Date: 27 June 2004
 To: T10 Technical Committee and SNIA OSD TWG
 From: Ralph O. Weber
 Subject: Rewrite of OSD Security and Policy/Storage Manager Models

The document shows all the changes to OSD r09 needed to:

Figure 1 — Example OSD Configuration

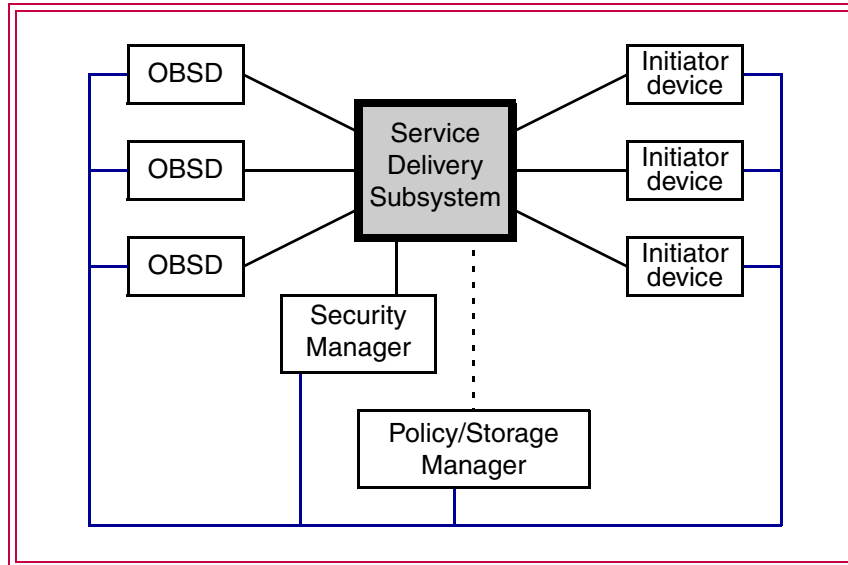
The example in this subclause (see figure 1) illustrates the three mandatory and two optional constituents of an OSD configuration:

Application clients using multiple SCSI initiator ports share directly access an OBSD (see 3.1.26) via the service delivery subsystem. The service delivery subsystem is used by the components in the OSD model, except possibly the **policy/storage manager and/or security manager**, to intercommunicate. The OSD security model (see 4.9) does not require the service delivery subsystem to provide security-related services (i.e., authentication and **confidentiality**), but is designed to take advantage of whatever security-related services are provided.

The **policy/storage manager** (see 4.x), if present, **coordinates access constraints between OSD device servers and application clients, preparing the capabilities application clients place in CDBs to gain access to OSD objects and command functions.**

The security manager (see 4.9), if present, **secures capabilities in cryptographically protected credentials for OSD device servers and application clients.**

The **policy/storage manager and security manager** may reside in the OBSDs, in applications clients, or as a separate entities.

The **policy/storage manager and security manager** may use the service delivery subsystem and be an application client, but **they** also may use another mechanism to communicate with the OSD device servers and application clients. **Security-related requirements on the communications mechanisms used by the security manager are described in 4.9.2**

Figure 2 — OSD security model transactions

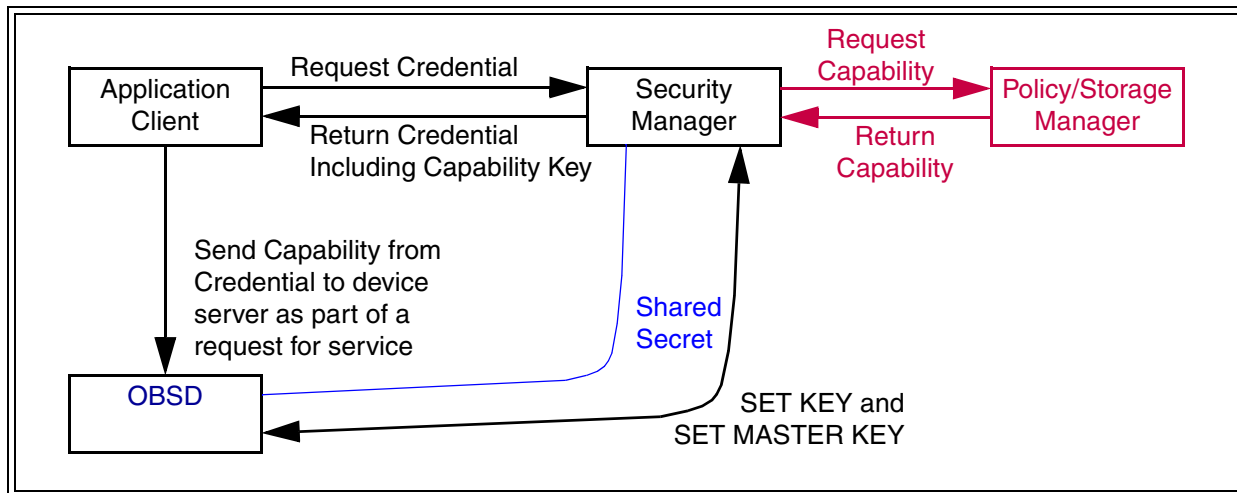
Figure 2 shows the flow of transactions between the components of the OSD security model.

The security manager generates credentials, including capabilities prepared by the policy/storage manager, for authorized application clients at the request of an application client. The security manager returns a capability key with each credential. The credential gives the application client access to specific OSD components. The capability key allows the application client and device server to authenticate the commands and data they exchange with an integrity check value (see 4.9.7).
